CITY OF KIRKLAND
Planning and Community Development Department
123 Fifth Avenue, Kirkland, WA 98033 425.587.3225
www.ci.kirkland.wa.us

MEMORANDUM

SUBJECT: TOTEM LAKE APARTMENTS
CONCEPTUAL DESIGN CONFERENCE
File No. CDC11-00001

ARCHITECTURAL SITE & FIRST FLOOR PLAN
 SCALE: 1/32"=1'-0"

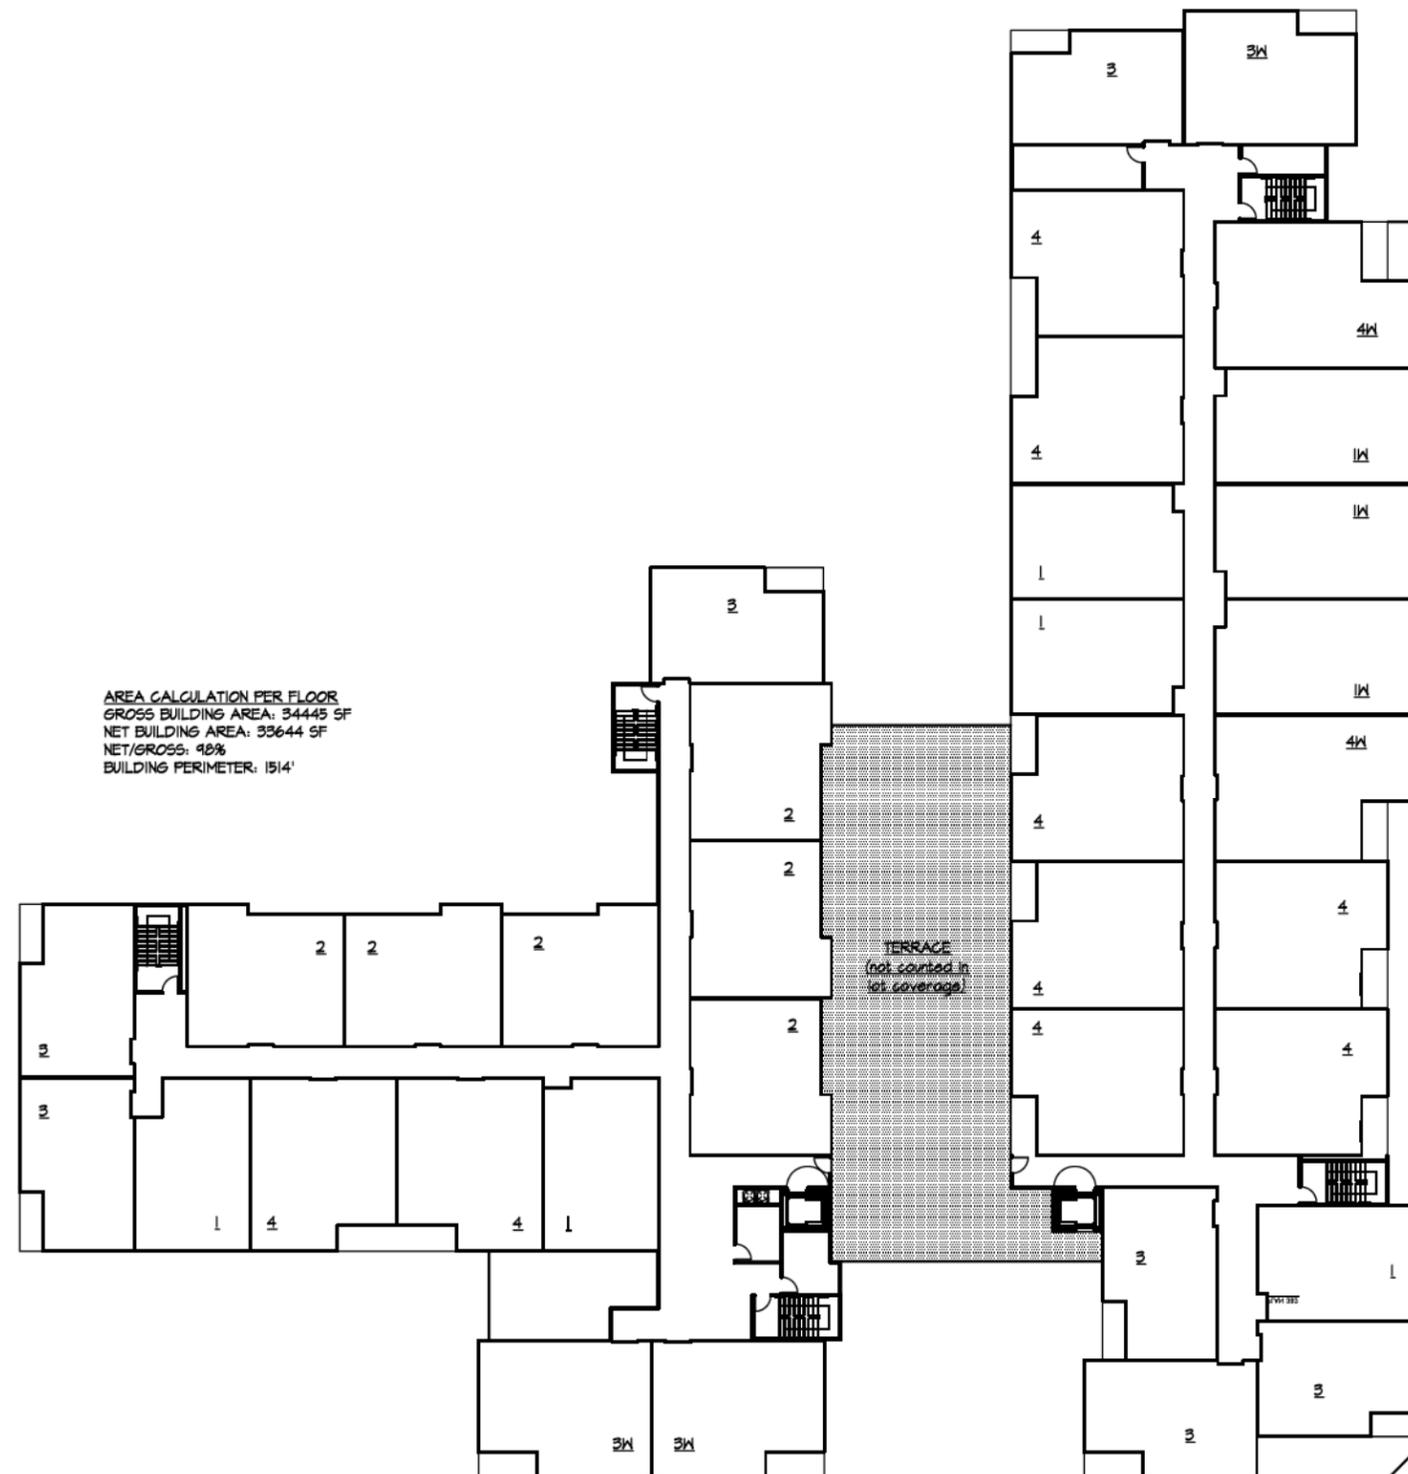
Also, in the North Rose Hill Business District, there is a guideline that states that a parking lot should not be located between the building and the street unless no other feasible alternative exists. The DRB should provide guidance regarding this issue. If a parking lot is allowed between the building and the street, a minimum 5' setback is required.

8. Driveway Access. The Public Works Department has reviewed the preliminary plans for redevelopment of the site and has indicated that the project design should provide a vehicular connection to the adjoining access tract to the west (123rd Ave NE). Opening of this connection may be waived if the applicant provides evidence to the City Attorney's Office that satisfactorily demonstrates that this connection cannot legally be provided by the applicant. In either case, the design shall not preclude opening of this connection at a future date.

VICINITY PHOTOS

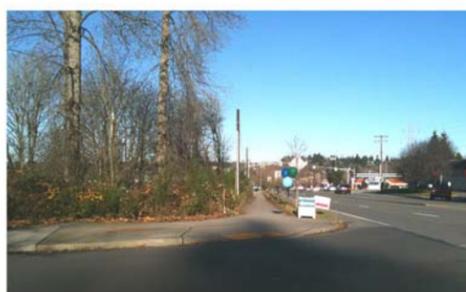
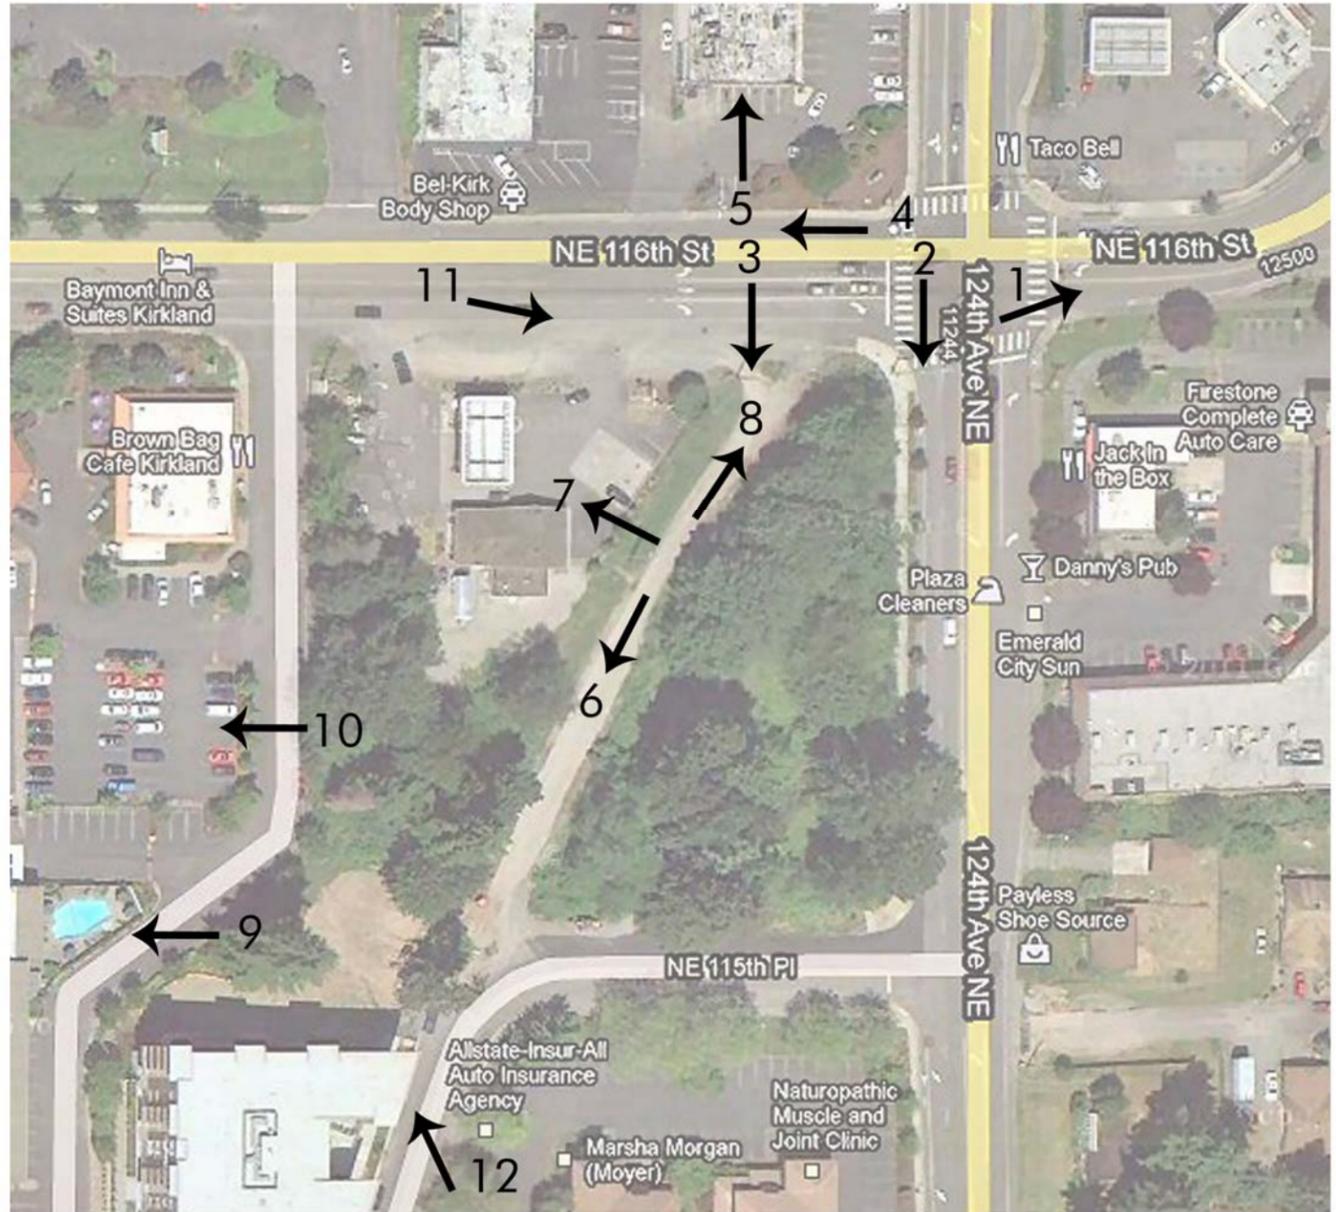
Additional descriptions of the site and vicinity as well as photographs prepared by the applicant are contained in Attachment 2, pages A8.1 – 8.2.
